City of Mississauga Department Comments

Date Finalized: 2021-12-01 File(s): A479.21

Meeting date:2021-12-09

Property Address: 3336 Ellengale Drive

Appendix 1 – Transportation and Works Comments

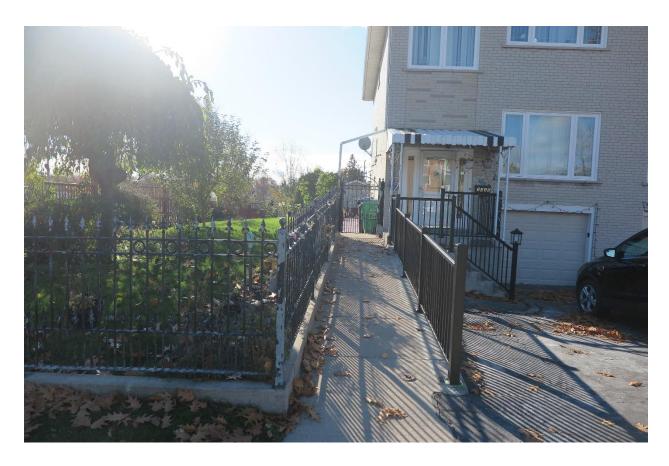
We note that the Transportation and Works Department has no objections to the proposed side door entrance as it will not impact or alter the existing grading and drainage pattern for this property.
